**CONSULTATION REPORT**

# **Report on the public consultation regarding the Proposal for Amendment to the T&C BSP FCR**

**16/07/2025**

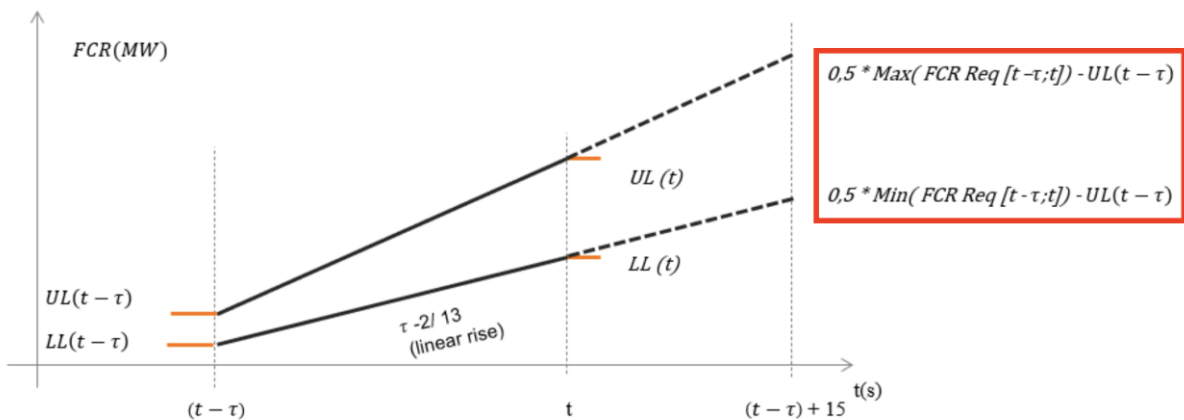
Also on p101, regarding the figures:

- We are not sure what is depicted, is it ULL and LLL?
- We are not sure over what index the Min and Max are applied.

Globally, the paragraphs 2.3.1.2 and 2.3.1.3 are quite obscure to us from the mathematical point of view even though we understand the general intention. We have also noticed differences in the formulas between the Explanatory Note and the Amended T&C, which make the understanding harder.

<p>Globally, the paragraphs 2.3.1.2 and 2.3.1.3 are quite obscure to us from the mathematical point of view even though we understand the general intention. We have also noticed differences in the formulas between the Explanatory Note and the Amended T&amp;C, which make the understanding harder.</p> <p>As a BSP we believe it is important that the concepts are clearly defined and understood by FCR suppliers and therefore kindly ask Elia to provide an updated documentation that would be easier to comprehend (with maybe more explanations between the mathematical formulas). We are happy to organize a call to explain in more detail what we are struggling to understand.</p>	
	Centrica	<p>We support continuous monitoring and activation control, and raise concerns on slower-reacting assets and outer frequency bands.</p> <p>We support the continuous monitoring and activation control proposed in the T&amp;C BSP FCR, which increases transparency and reduces the risk of significant penalties due to random sampling.</p> <p>However, we raise concerns about the potential complexity introduced by derogations for slower-reacting assets ('Additional Properties') and disparities between the monitoring of inner and outer frequency bands. We invite Elia to provide detailed guidelines and examples to better evaluate the impact of the new monitoring and activation control rules, covering various use cases.</p>	<p>Elia thanks Centrica for the support on the proposal for continuous monitoring and activation control. Elia is aware of the added complexity due to derogations and the effect on the calculation of the inner and outer frequency bands and has complemented the T&amp;C BSP FCR to clarify how such derogations would be considered in the formulas of the proposed activation control. Elia has provided detailed guidelines through the T&amp;C BSP FCR and the explanatory note and has made some corrections with the aim to improve the clarity of these documents. Elia invites Centrica to contact Elia in case of remaining questions.</p>

Figure 1: The accepted response of FCR Provider to change in frequencies

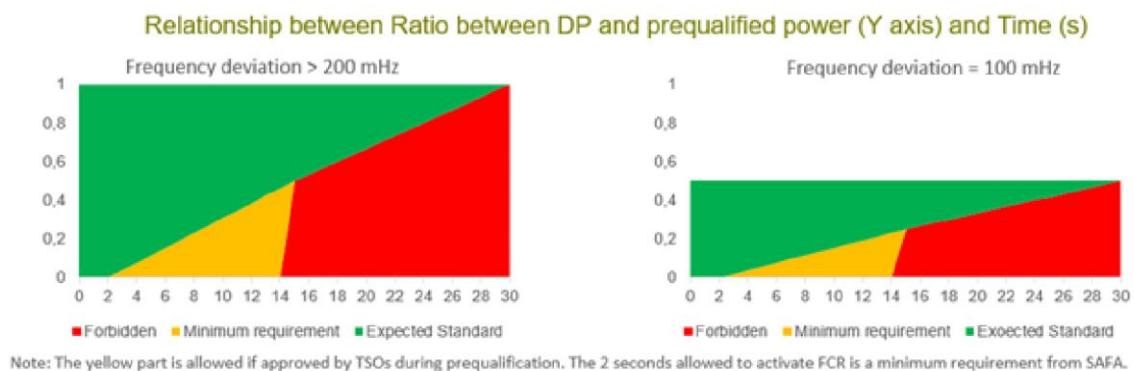
A last remark is on the Amendments to the Prequalification test phase 1 where Elia proposes to remove the 5 seconds tolerance. This would mark a difference with normal FCR delivery where 2 seconds (or more in case of derogation) are tolerated for assets to start reacting to a frequency deviation (as long as the reaction delay is not artificial). If one takes the Figure “accepted response of FCR Provider to change in frequencies” shared by Elia in the Explanatory Note, the expected reaction at 25% after 7,5 seconds (without the 5 sec tolerance) is above the line separating the green and yellow areas. As such, the FCR prequalification requirements would exceed the FCR delivery requirements. We believe they should remain aligned as the purpose of FCR PQ is to check whether an asset matches the requirements for FCR delivery. Therefore, a reacting time tolerance should be kept in the PQ test.

<p>ing to a frequency deviation (as long as the reaction delay is not artificial). If one takes the Figure “accepted response of FCR Provider to change in frequencies” shared by Elia in the Explanatory Note, the expected reaction at 25% after 7,5 seconds (without the 5 sec tolerance) is above the line separating the green and yellow areas. As such, the FCR prequalification requirements would exceed the FCR delivery requirements. We believe they should remain aligned as the purpose of FCR PQ is to check whether an asset matches the requirements for FCR delivery. Therefore, a reacting time tolerance should be kept in the PQ test.</p>	<p>tivation in 15s and 100% activation in 30s. The 2s delay during normal FCR Delivery is required to provide the BSP with time to process the frequency measurements, calculate the required reaction and send the signal to the asset. This is not needed when following a predetermined profile. Therefore, Elia has the opinion that the proposed requirements of the prequalification test do not exceed the FCR delivery requirements.</p>
